Strathfield Local Planning Panel Meeting

Thursday, 6 May 2021

TO: Strathfield Local Planning Panel Meeting - 6 May 2021
REPORT: SLPP – Report No. 1
SUBJECT: DA2017/142/2 - 29 POMEROY STREET, HOMEBUSH
 LOT 35 DP 834
DA NO. DA2017/142/2

Proposal:	Section 8.2A Review of the consent of S4.55 (2) DA2017/142/2 modification application to increase the number of boarding rooms from thirteen (13) to nineteen (19) and ancillary building works.
Applicant:	Bechara Chan & Associates
Owner:	Maxim Property Holdings P/L
Date of lodgement:	4 January 2021
Notification period:	13 January 2021 to 29 January 2021
Submissions received:	Nine (9)
Assessment officer:	D Strbac
Estimated cost of works:	Nil
Zoning:	R3 Medium Density Residential - SLEP 2012
Heritage:	No
Flood affected:	Yes
Is a Clause 4.6 variation proposed?	No, however a further 260mm increase to overall building height from 11.67m to 11.93m is sought.
RECOMMENDATION OF OFFICER:	APPROVAL

Figure 6: Proposed basement floor plan

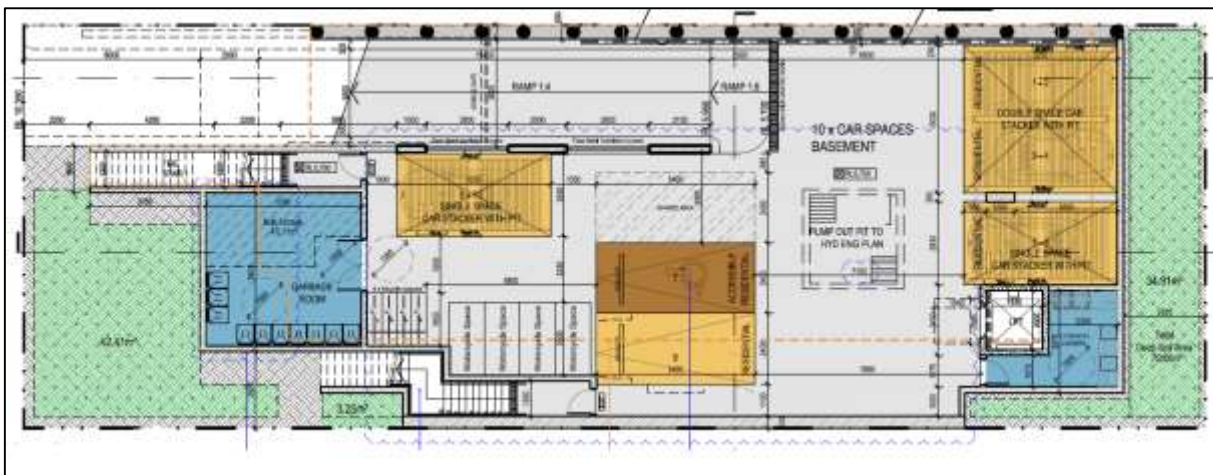
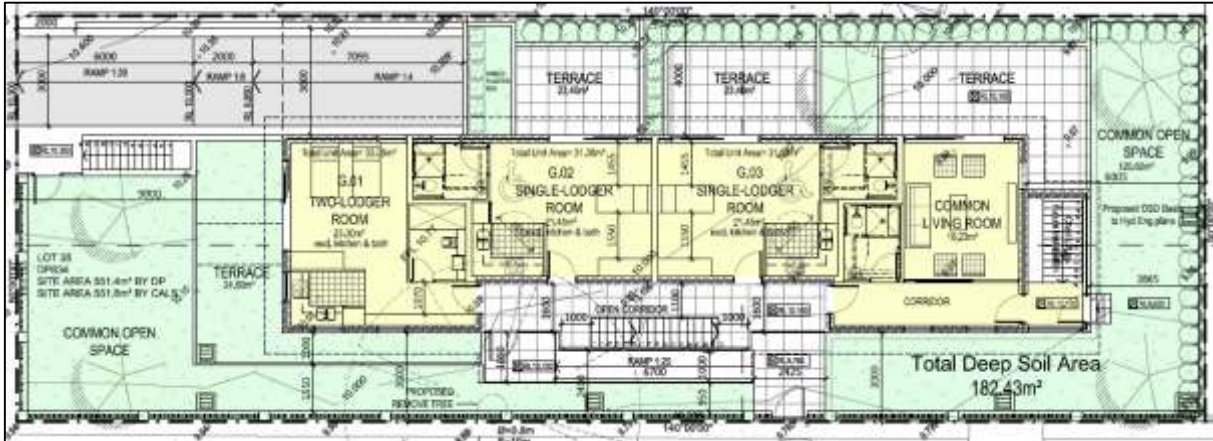
- Reconfiguration of basement layout to accommodate new laundry;
- Reconfiguration of motorcycle and bicycle spaces;
- Reduction of bicycle parking spaces from ten (10) spaces to four (4) spaces;
- Increase in motorcycle parking spaces from three (3) spaces to four (4) spaces;
- Relocation and enlargement of garbage room and bulk bin storage;
- Provision of four (4) car stackers to provide a total of ten (10) car parking spaces; and
- Additional of a lift.

Figure 10: Ground Floor – proposed modification.

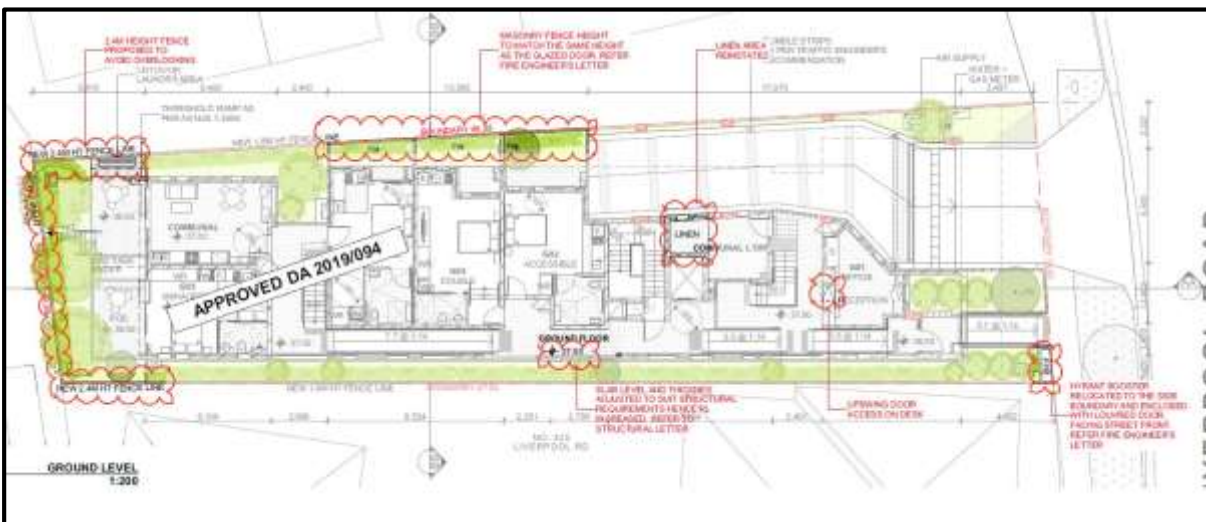
- Entrance modified for accessible access;
- Sliding door for office removed;
- Office layout re-arranged for improved space usage;
- Fire stairs amended to comply with BCA;
- Lift size amended as per lift supplier’s specification;
- Communal laundry updated by removing the door for improved amenity and space flexibility; and
- RL for Unit G02 increased from 37.30 to 37.55 due to slab thickness.
- Ramp adjusted due to structural slab amendments from 4.2m length to 7.7m length;
- Hydrant booster relocated as advised by engineer, covered with louvre door; and
- Updated timber fence at North East elevation to masonry fence as per fire engineer's recommendation. Masonry fence height to be at the same height as glazed doors for Units G02, G03, G04.

Figure 11: Level 02 – proposed modification.

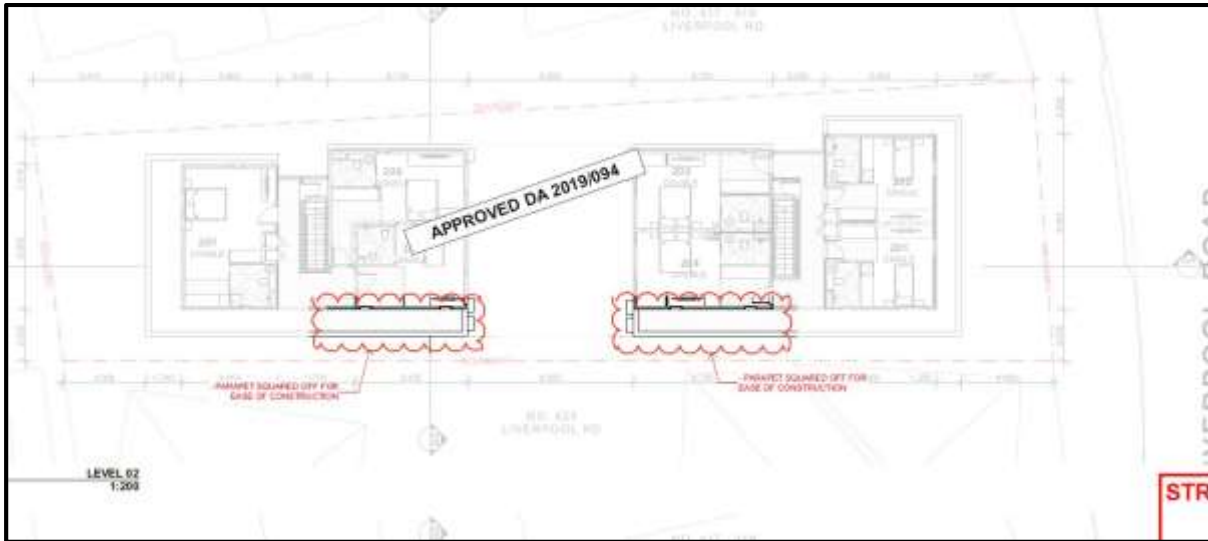
- Parapet extended for ease of construction but to remain as non-trafficable area.
